Metro Central Joint Development Assessment Panel Agenda

Meeting Date and Time: 11 September 2017; 2pm
Meeting Number: MCJDAP/255
Meeting Venue: City of South Perth
Cnr Sandgate and South Terrace
South Perth

Figure 3 - Swept Paths for fuel tanker (with previous DoP recommendations in red)

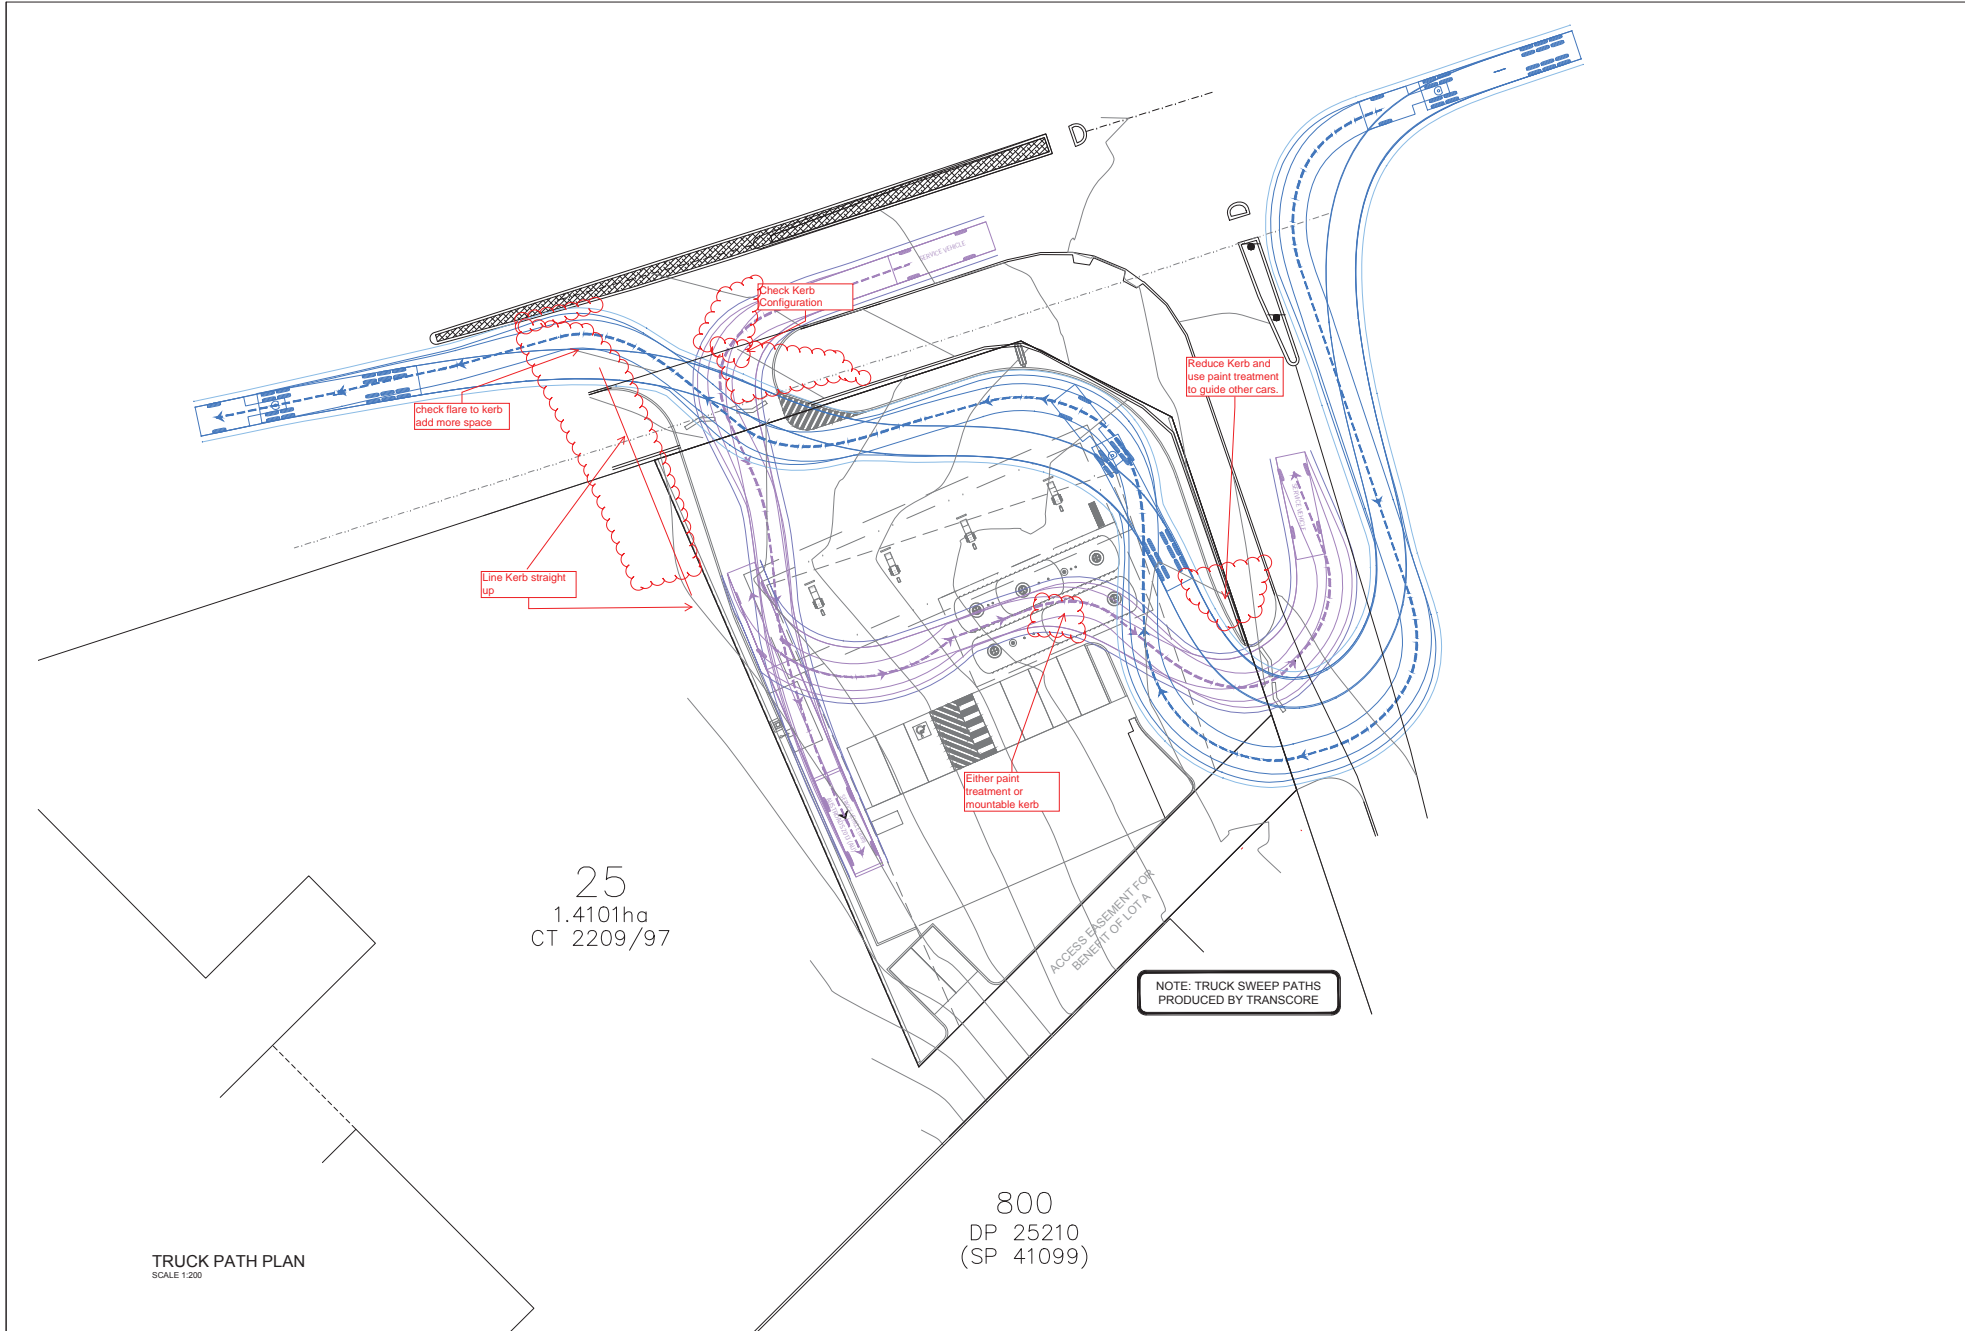
It is understood that the swept paths shown in **Figure 17** are based on the movements of a 19m long fuel tanker. The Department recommends consideration be given to making minor modifications as follows:

Figure 4 - Site Plan

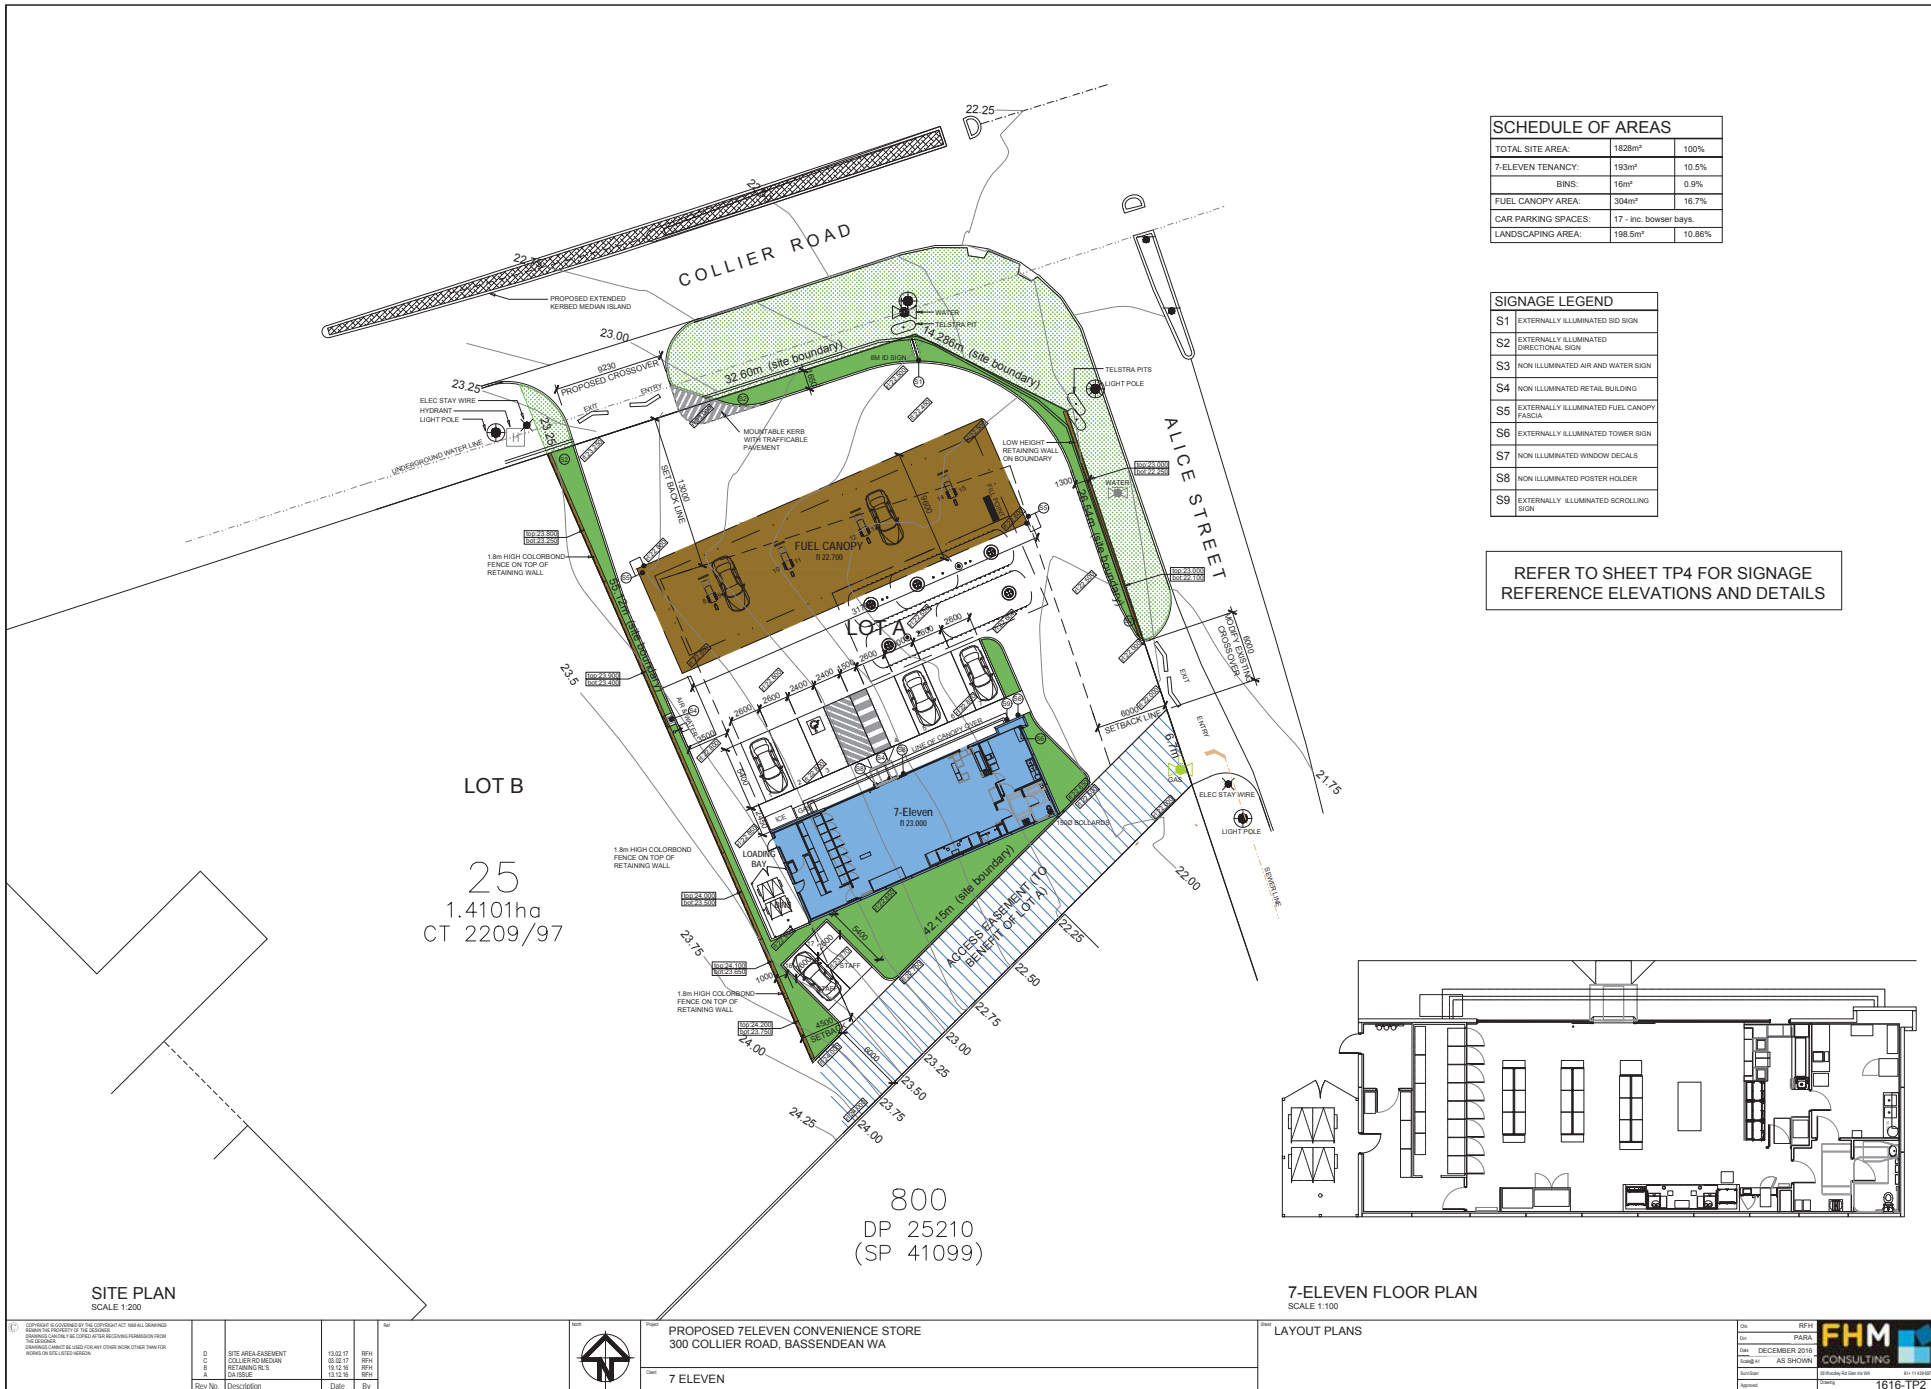
The TIA refers to the site plan shown at **Figure 4** as evidence of this, however the site plan does not show any footpaths. It is therefore recommended that any future iterations of the TIA be updated to correct for this omission.

Figure 17 - Recommended changes to kerbs for fuel tanker access

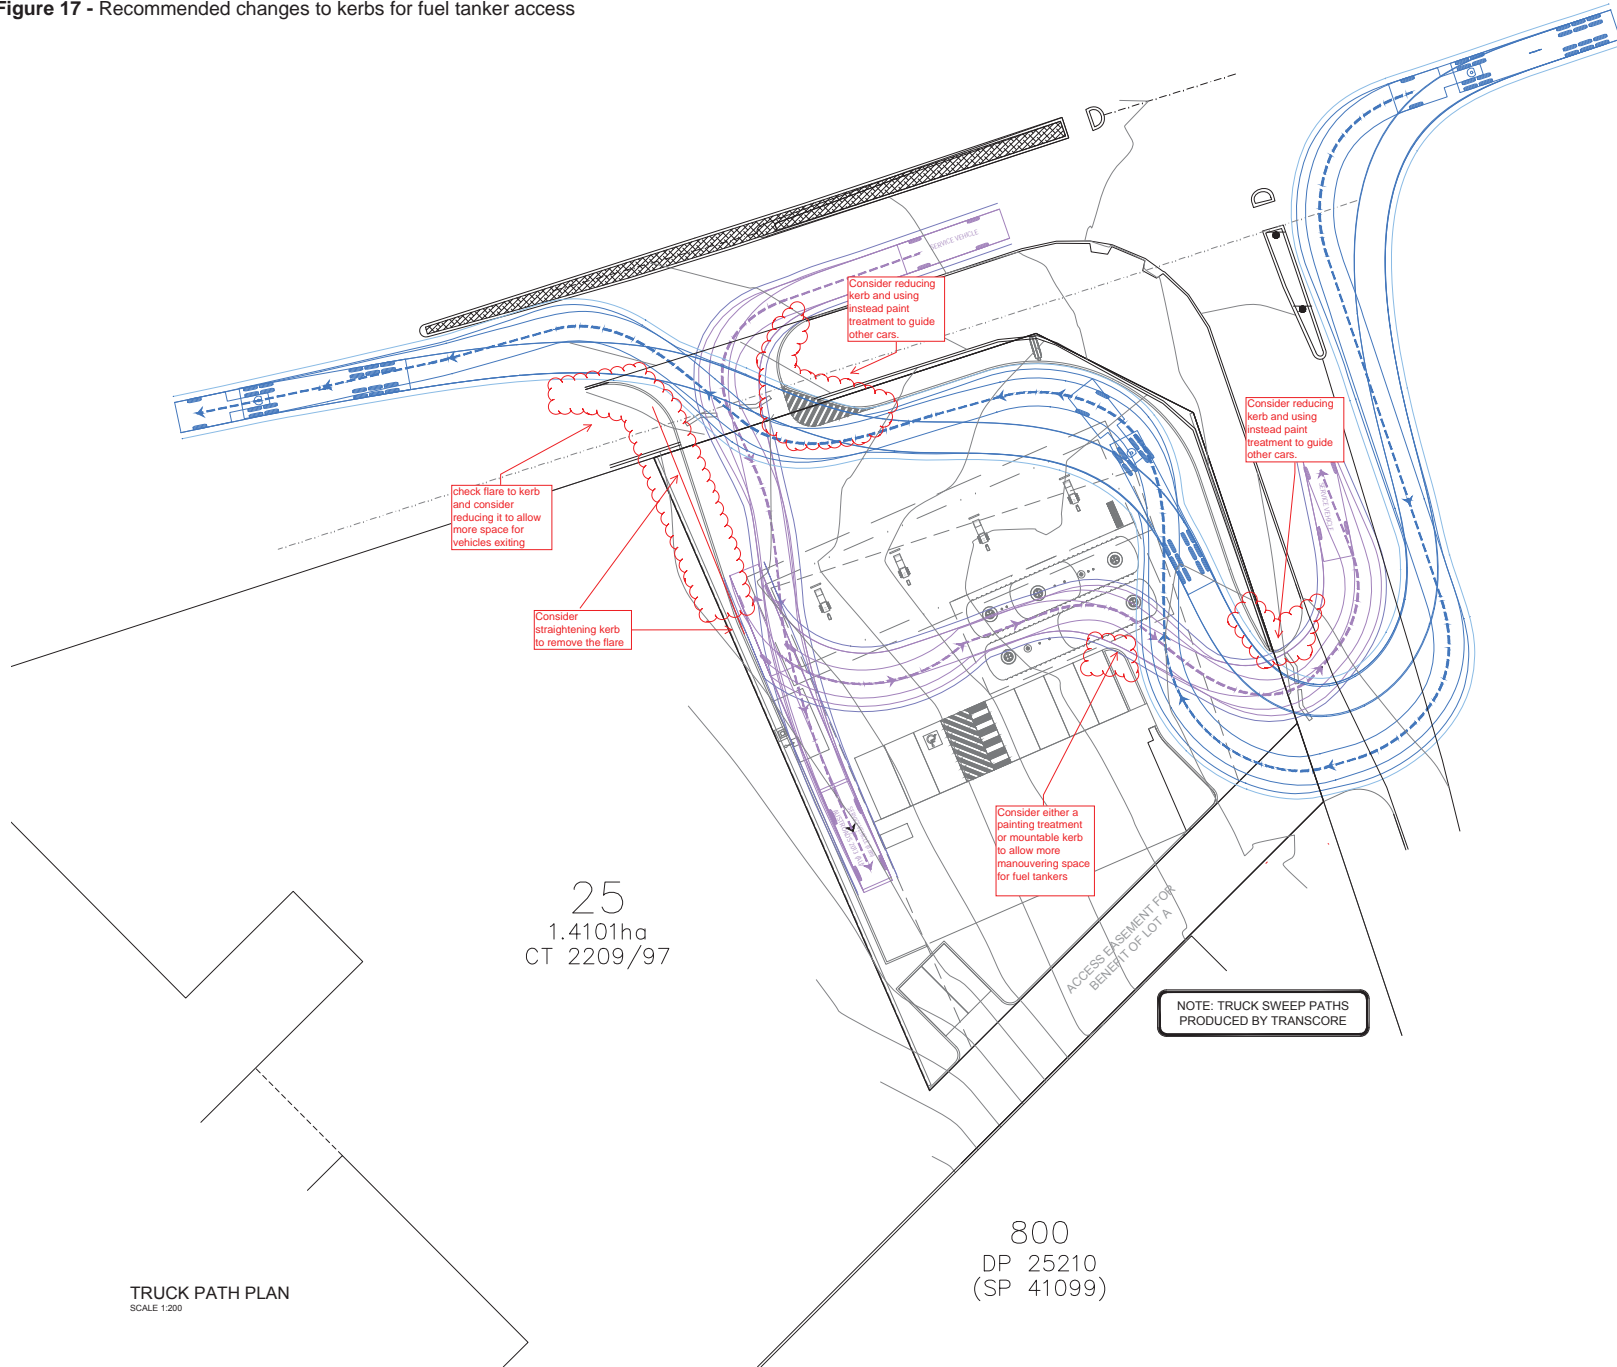
These recommendations are shown in red on the marked up map shown at **Figure 17**.

- b. A reduced height to S1 – High Main Price Board to a maximum height of 6m.
 - c. Straightening of the kerb on the western side of the site to increase the width of the proposed crossover as shown in red on drawing titled Figure 17. The crossover wing radius must be a minimum of 5.0m in accordance with the Towns crossover specifications.
